**1.0 APPLICATION SUMMARY**

**Introduction Summary:**  
 PD 20-0338 was approved in 2020 to allow a technical school and related office uses in the subject site. The applicant requests modifications to the approved building area and setback requirements.

APPLICATION NUMBER: PRS 23-0080

**Re: PRE-APPLICATION REVIEW FOR ACCESS CONNECTION PERMIT REQUEST**

### 2.5 Proposed Site Plan (partial provided below for size and orientation purposes. See Section 8.2 for full site plan)

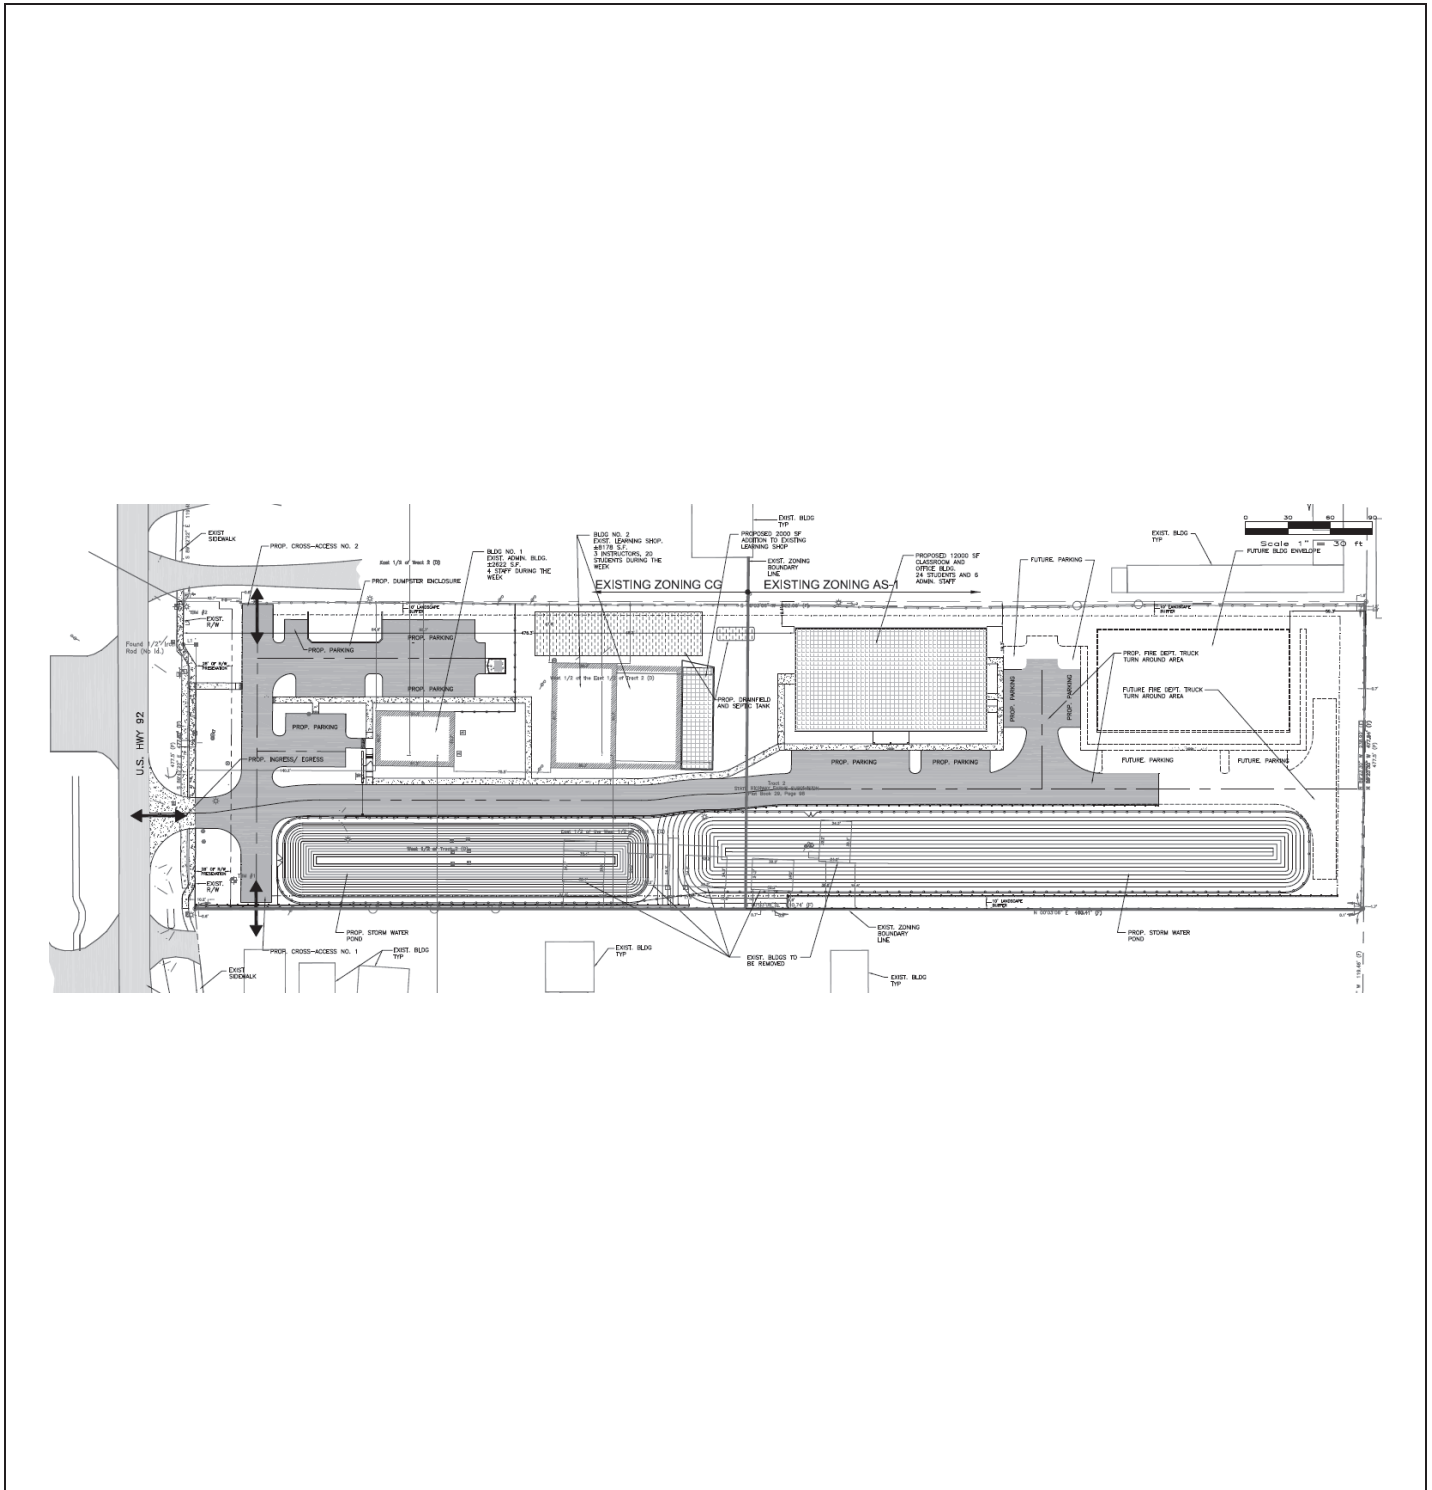
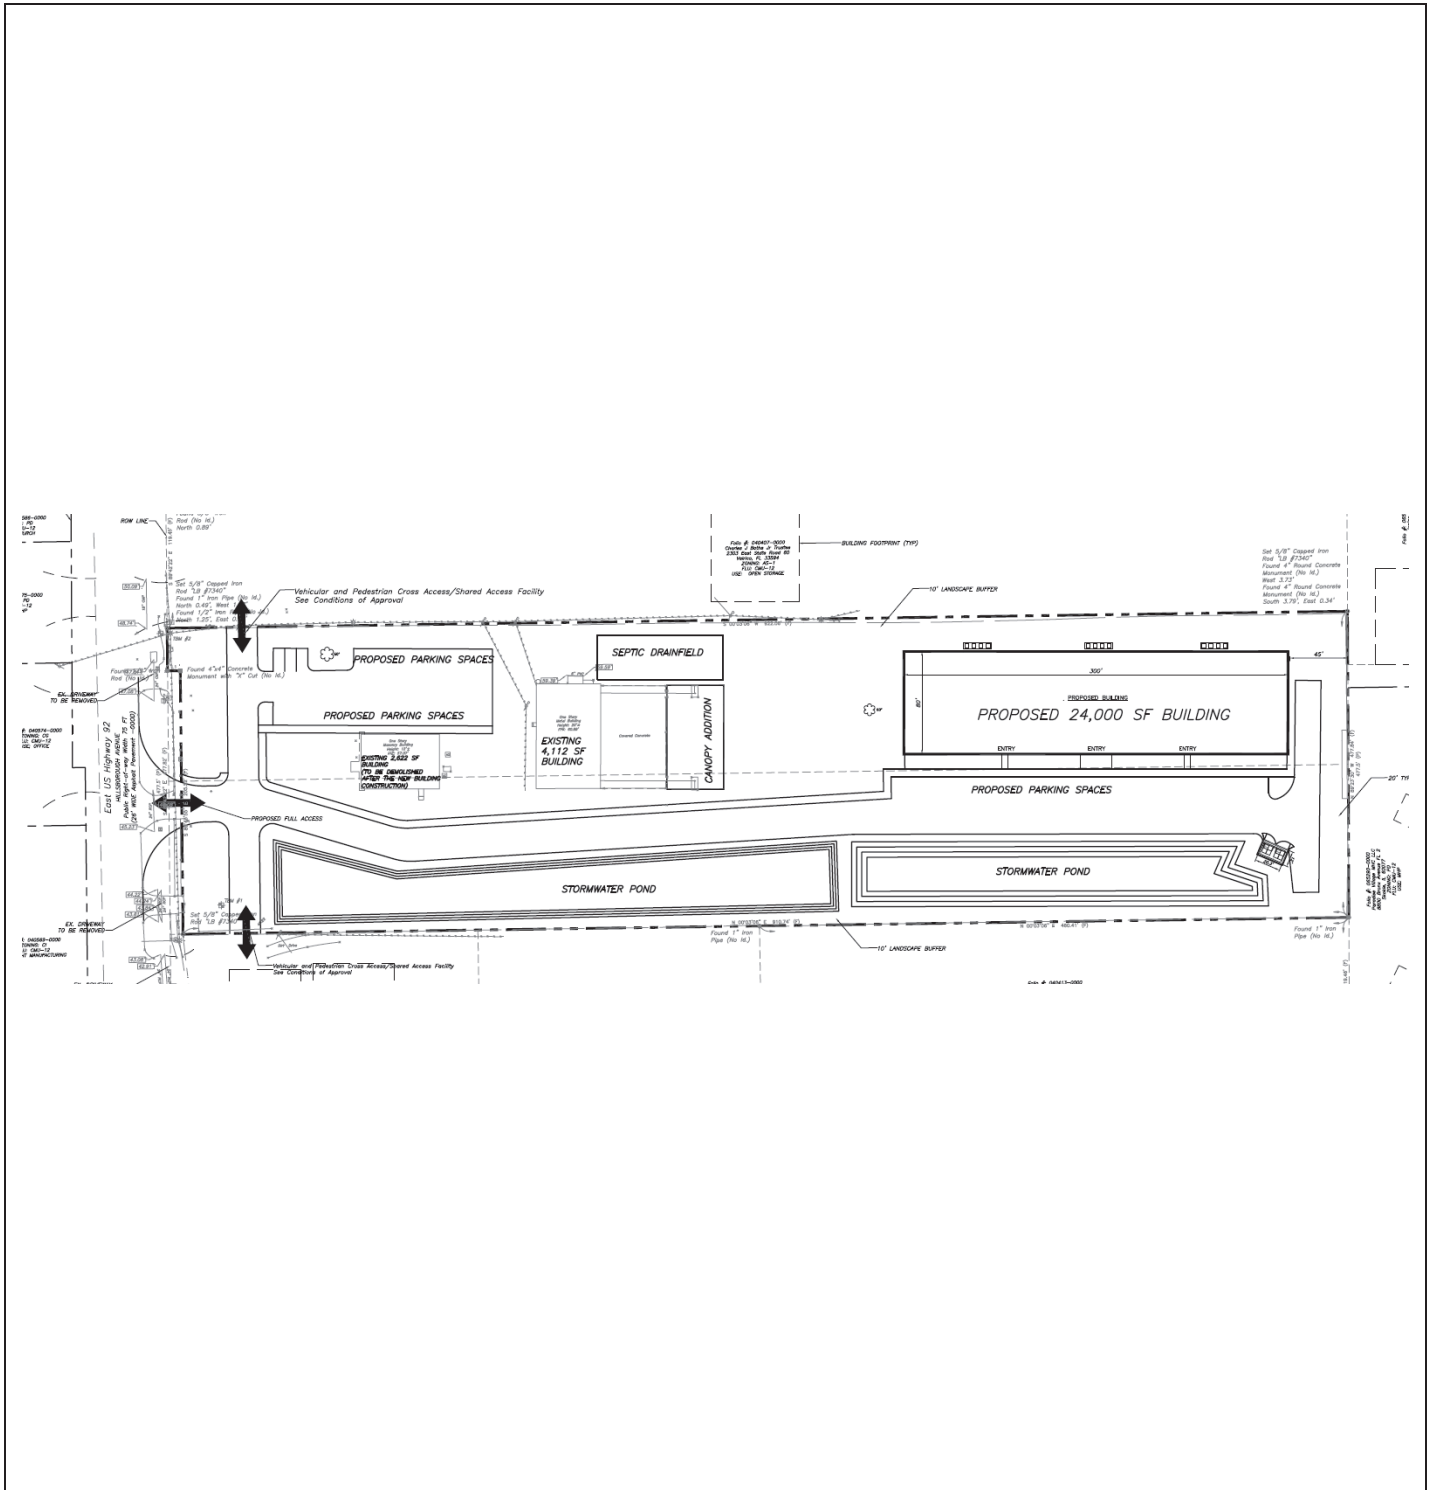
Staff finds the proposed request to be compatible with the surrounding development pattern. The requested setback reduction from a 55-foot to a 45-foot setback along the southern boundary will still exceed typical minimum setbacks (20 feet) that would be required for non-residential buildings with a maximum building height of 20 feet. With the reduction in building square footage and maximum number of students the overall intensity of the project will be reduced. Therefore, this minor modification will have little effect on the general character of the subject site, zoned PD today.

way from property on the north side of the roadway. As such, the applicant’s proposed PD site plan removes the corridor preservation area and staff is recommending to delete condition of approval # 7 related to corridor preservation.

1. The project shall be developed with a technical school and related office uses, with a maximum ~~36,800~~ 30,734 sq. ft. of building space. Maximum number of students shall be ~~79~~ 50.

2. Development standards shall be as indicated on the site plan. A minimum of ~~55~~ 45 feet of building setback shall be maintained along the south PD line.

DRAWING TITLE:  
**OVERALL SITE PLAN**

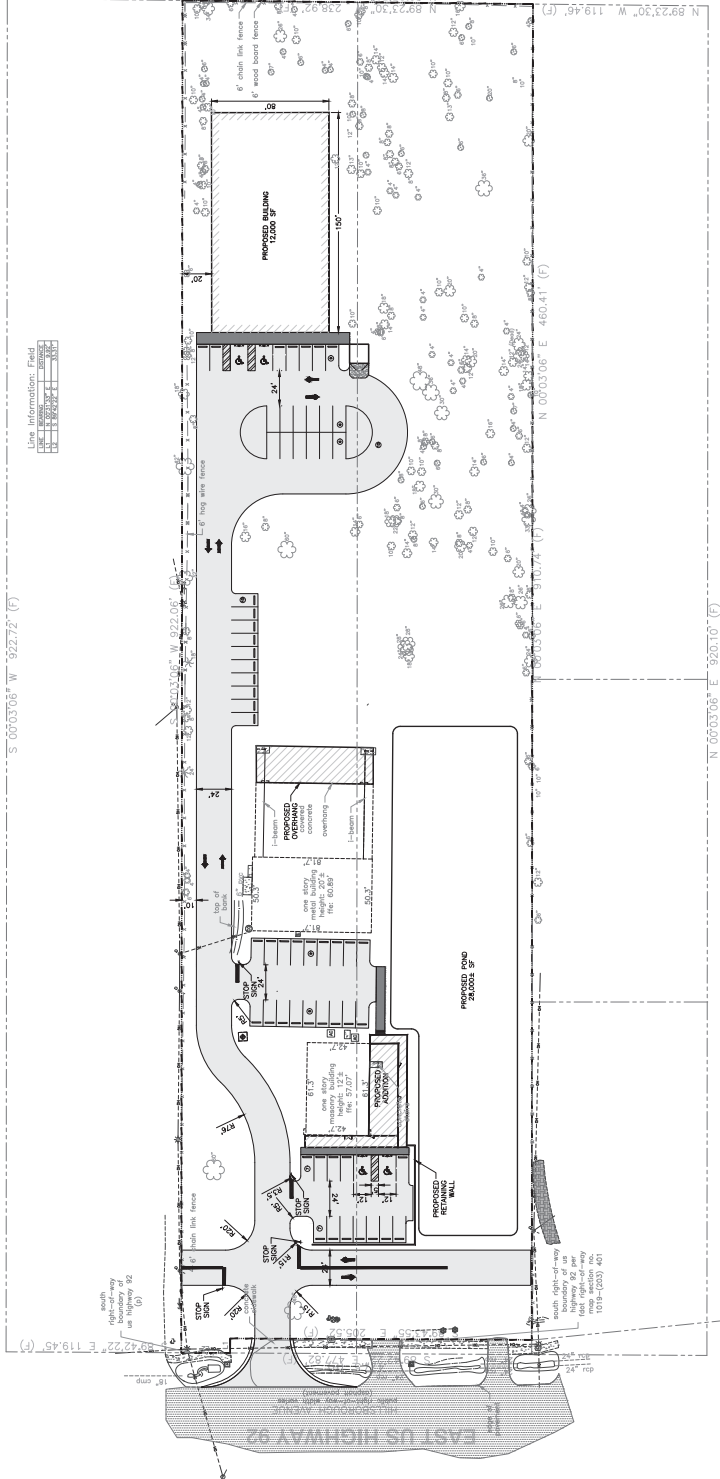
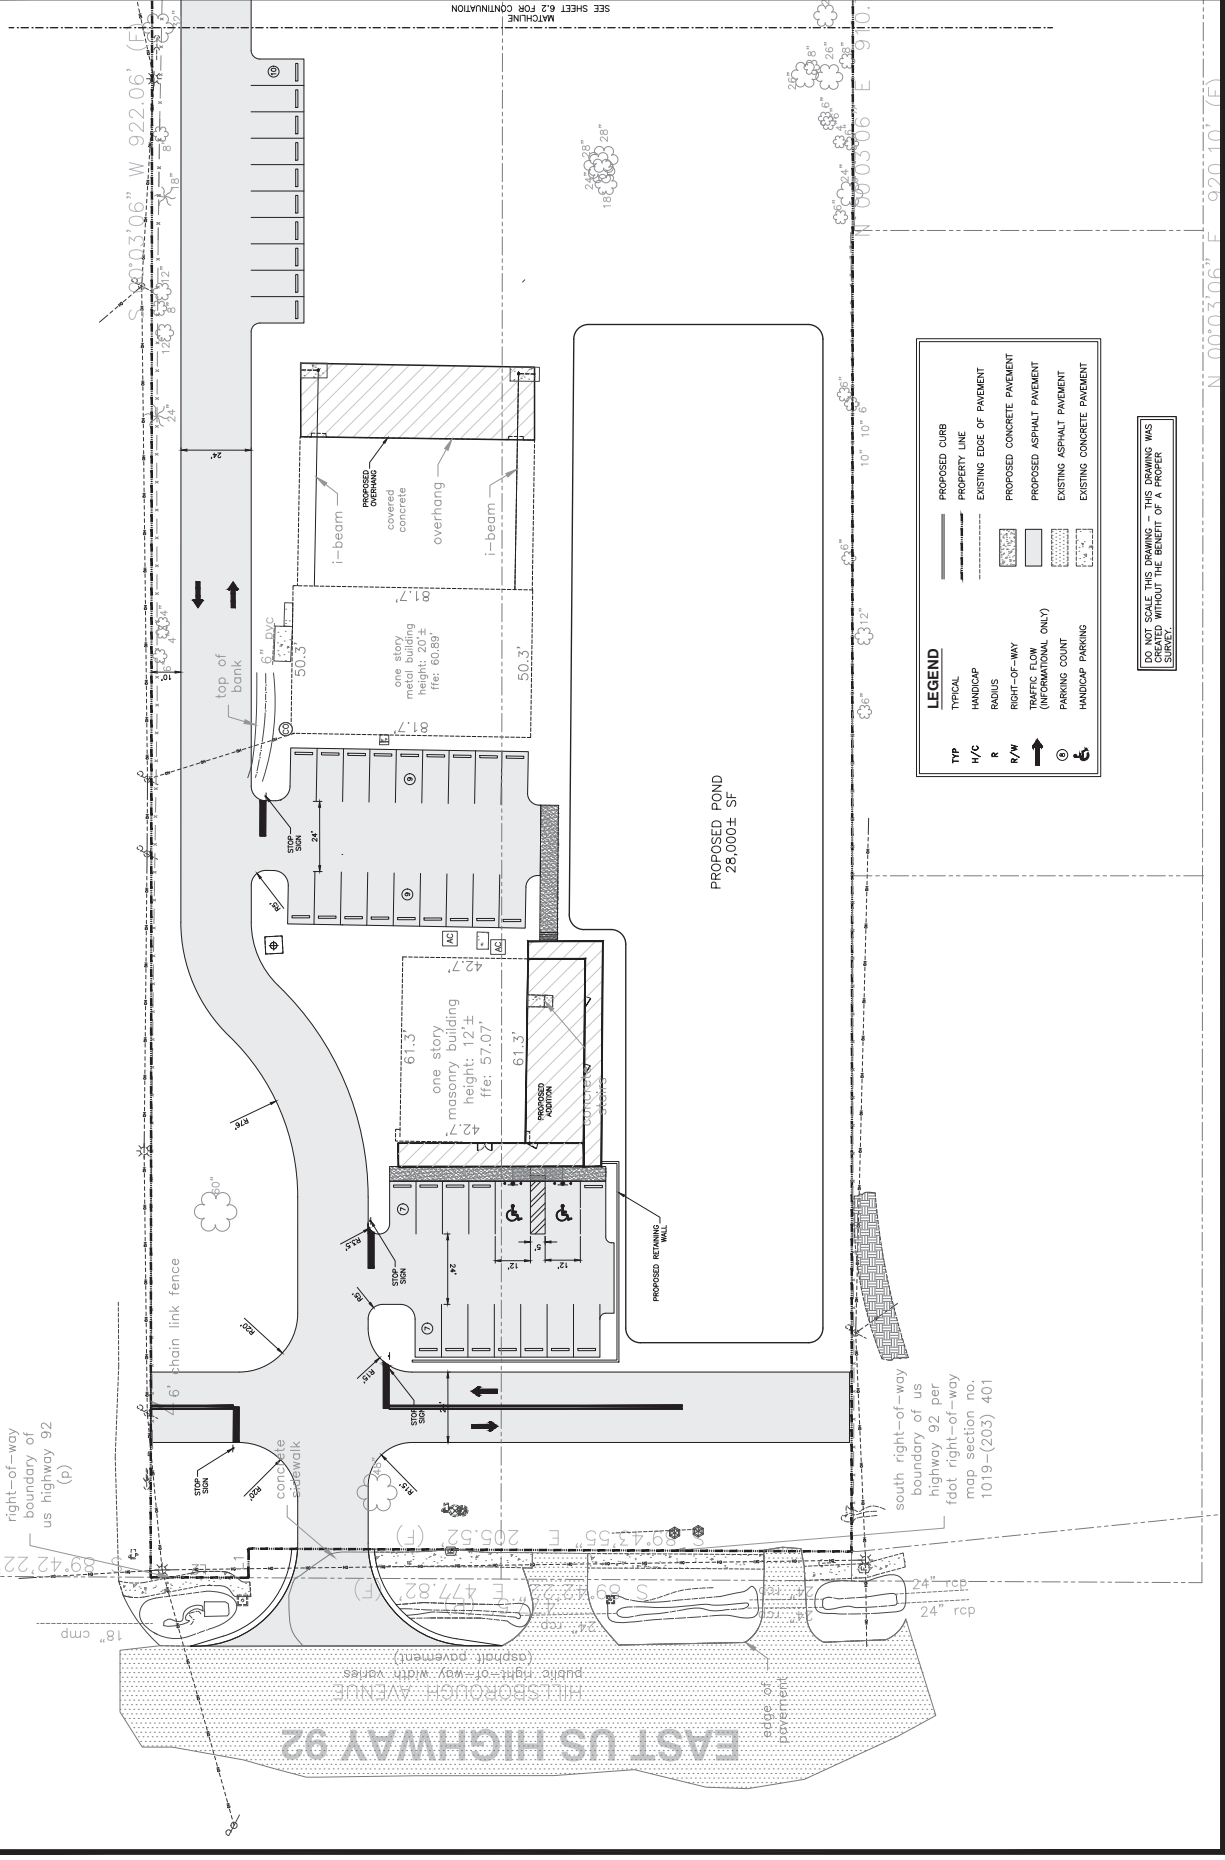
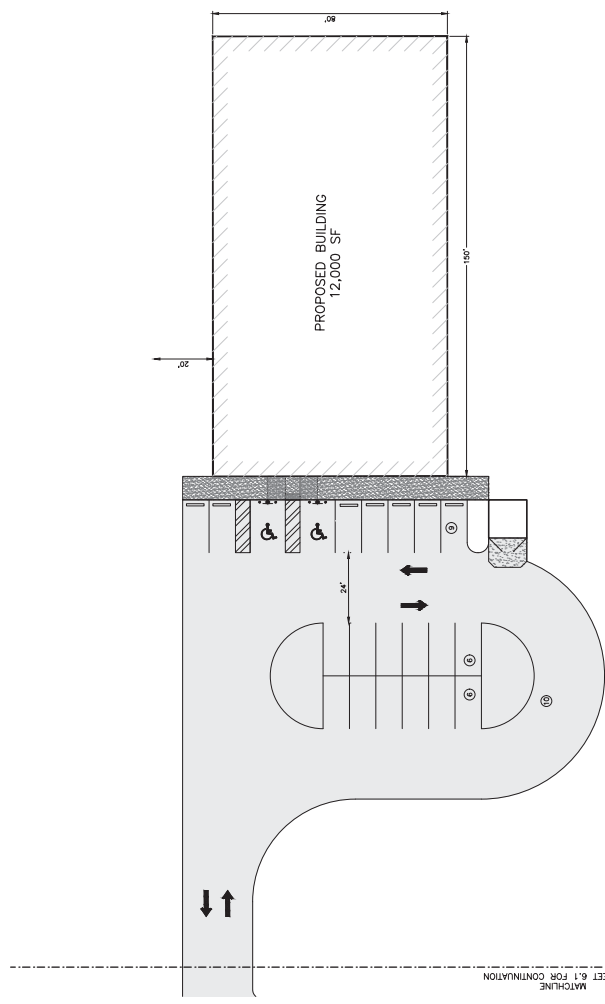
4. Site plan has been flipped from what was proposed previously. At the original meeting, the Department requested that the driveway be shifted to the western end of the frontage. The currently proposed plan shows the driveway on the east side of the property due to the west end being the low point and was intended for stormwater retention.

5. The Department has since agreed that the driveway can be located at the eastern side of the property.
6. Cross-access to the east and west will need to be provided. Access must be labeled on plans as a "Shared Access Facility". The Department expects this to be a shared access.

9. Sidewalk connection to the state road will be required that ties into the sidewalk connecting to all the buildings onsite.
10. No curb is allowed on this type of roadway. Redesign to show paved shoulder that wraps around and ties into the to the R/W.

12. Will need to verify property lines and survey information accuracy.
13. Minimum driveway radii of 35'. 50' is preferred.
14. 24' minimum driveway width.

18. Maintain 20' pedestrian sight triangles and draw the triangles on the plans to show there are no obstructions taller than 24" within the triangles. (See example below)
